# Petone to Melling Cycleway

## Pre-Opening Road Safety Audit

28 May 2024

Figure 36: Proposed wayfinding signage for Dowse Interchange bypass.

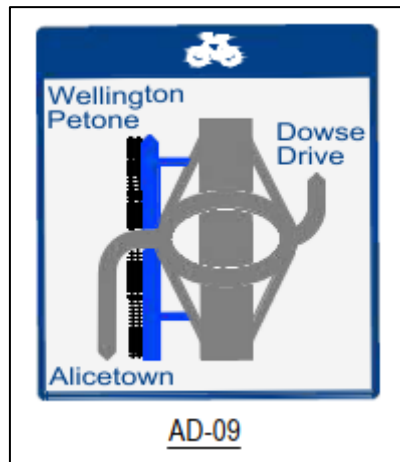
According to the designs, the sign shown in 36 is to be installed on approach to the start of the bypass. This sign is intended for people cycling on SH2, advising them of the upcoming bypass. There is too much information to comprehend quickly for someone riding on SH2.

- 59 Re-consider how wayfinding signage can be implemented at this location to achieve the desired behaviour and to cyclists to use the bypass rather than staying on SH2 and crossing the Dowse interchange off- and on-ramps.
- (a) Using the phrase 'Dowse interchange cycle bypass' or similar on wayfinding signage is probably enough to explain to path users what the extra, contra-flow lane is for.
  - (b) Provide signage at either end which explains to northbound and southbound cyclists how to access Maungaraki and Alicetown via SH2.

Frequency:	Severity:	Rating:
<i>Crashes are likely to be Infrequent</i>	<i>Death or serious injury is Very Likely</i>	<i>The safety concern is Significant</i>
<b>Designer Response:</b>	The Designer does not agree with the Safety Auditor wrt the ADS being confusing and recommends no change to the current signage. The designer recommends markings on the southbound exit slip shoulder saying "Wellington/Petone" with a left arrow within a green sharrow marking. WRT Recommendation 59(b), refer to the Designers response in Section 11.3 above. -	
<b>Safety Engineer:</b>	<b>Agree with designer except sharrow not appropriate. Left arrow with a cycle marking should be effective.</b>	
<b>Client Decision:</b>	Install markings on the southbound exit slip shoulder saying "Wellington/Petone" with a left arrow with cycle marking, in a position to allow appropriate response time to then utilise the bypass. Install northbound wayfinding for Alicetown/Maungaraki at northern end of bypass (in a position for a u-turn manoeuvre, not a wrong-way entry into bypass lane).

Figure 39: Observed path of vehicles exiting Park and Ride into where a cyclist may be waiting to turn into P2M cycle path.

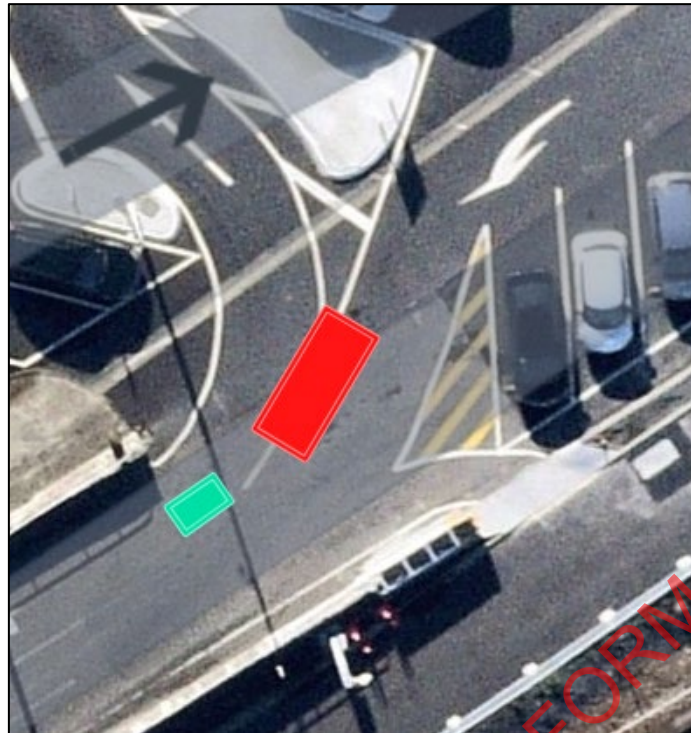
Another risk for cyclists accessing the P2M path via the entrance south of Petone Station is from Park and Ride car park users. Vehicles traveling the wrong way were observed several times by the SAT, as shown in Figure 37. Vehicles exiting the right way were observed to often cross the centre line. Vehicles exiting the wrong way and right way are likely to be tracking in the path of a cyclist waiting to turn right onto P2M, as shown in Figure 38.

<b>Frequency:</b> <i>Crashes are likely to be Infrequent</i>	<b>Severity:</b> <i>Death or serious injury is Unlikely</i>	<b>Rating:</b> <i>The safety concern is Minor</i>
<b>Designer Response:</b>	Physical barriers or treatments as stated in Recommendation 63 and 64 cannot be installed as this is KiwiRail's heavy maintenance vehicles (under pilot vehicle) route to be able to access the northern end of the Petone station carpark and the rail corridor. The Designer recommends a give way hold line and associated signage be installed for vehicles exiting the carpark to give priority for any cyclist wanting to turn right into the shared path.	
<b>Safety Engineer:</b>	Additional RD-1R could be installed to direct cars not to exit out of the entrance.	
<b>Client Decision:</b>	Existing markings sufficient, risk is minor. No action.	
<b>Action Taken:</b>	nil

Figure 43: Detailed design drawings at northern end of Park and Ride.

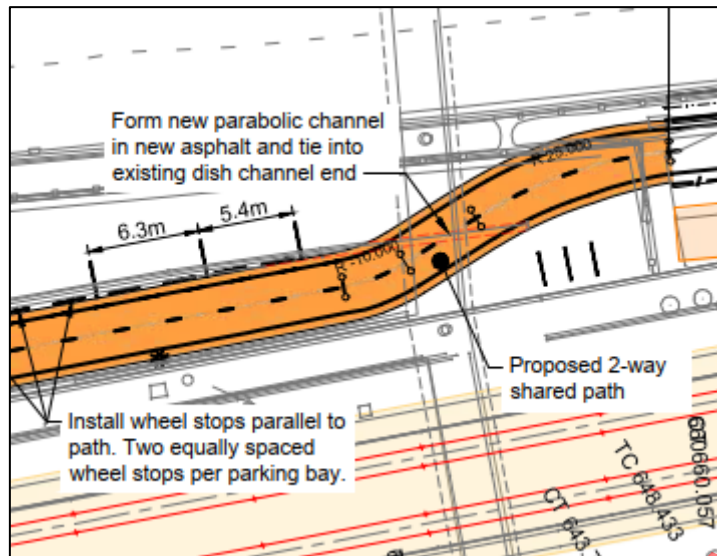
At the northern end of Petone Station, the cycle path passes adjacent to the end of the Park and Ride, as pictured in Figure 41. There is a risk of vehicle encroachment to the path as vehicles manoeuvre into car parking spaces. Without a physical barrier, there is also a risk of vehicles illegally parking over the path. This increases the risk of a cyclist vs vehicle crash and reduces the level of service for cyclists.

- 70 Remove any car parks which are not possible to park in without encroaching into the cycle path.
- 71 Provide more physical separation between the path and the space adjacent to prevent vehicle encroachment into the cycle path. There are a range of options to choose from using 'Protected Cycle Lane Barrier Selection Matrix'.<sup>9</sup> Access for KiwiRail maintenance vehicles must be retained.

Frequency:	Severity:	Rating:
Crashes are likely to be Infrequent	Death or serious injury is Unlikely	The safety concern is Minor
Designer Response:	Removing carparks will require the agreement of GWRC. The arrangement as constructed has been designed in conjunction with GWRC. Currently vehicle drivers are not parking on the shared path (a wheel stop will not stop a determined driver to straddle their parked vehicle into the shared path) and the Designer believes the area should be monitored for complaints before implementing any other measures, which must not impede KiwiRail's access to the rail corridor.	
Safety Engineer:	Agree with recommendation 70 if GWRC are amenable to the idea. Otherwise, recommend speed humps on edge of roadway and extra cycling only green block surfacing in cycle path.	
Client Decision:	The accessway must be maintained and the number of car parks preserved. Speed humps are unlikely to deter vehicle encroachment. Due to the constrained environment vehicle speeds will already be low so humps are not required as a speed control. Acknowledging cars will occasionally temporarily enter the cycleway (as they do when accessing driveways on Bridge St), the green block can provide increased awareness to drivers of the potential conflict with cyclists and to have increased awareness. Install cycling only green block on path at conflict point.

Figure 47: Advisory signage recommended for cyclists on SH2 to use Dowse bypass.

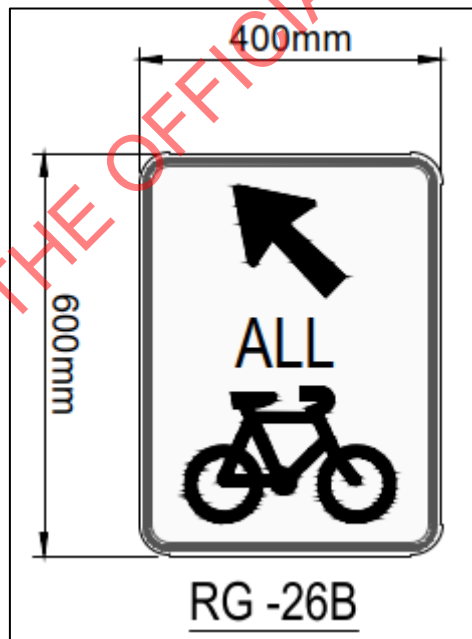
According to Sheet 1 of the 'Sign Details' the sign should be advisory (with a black border), rather than regulatory (with a red border).

As part of the exercise to ensure good wayfinding at the Dowse interchange (as described in Chapter 11), the regulatory or advisory signage could be reviewed.

14.1.2 Agree, but only requires a border change to black. **Action** – affix black tape to border.
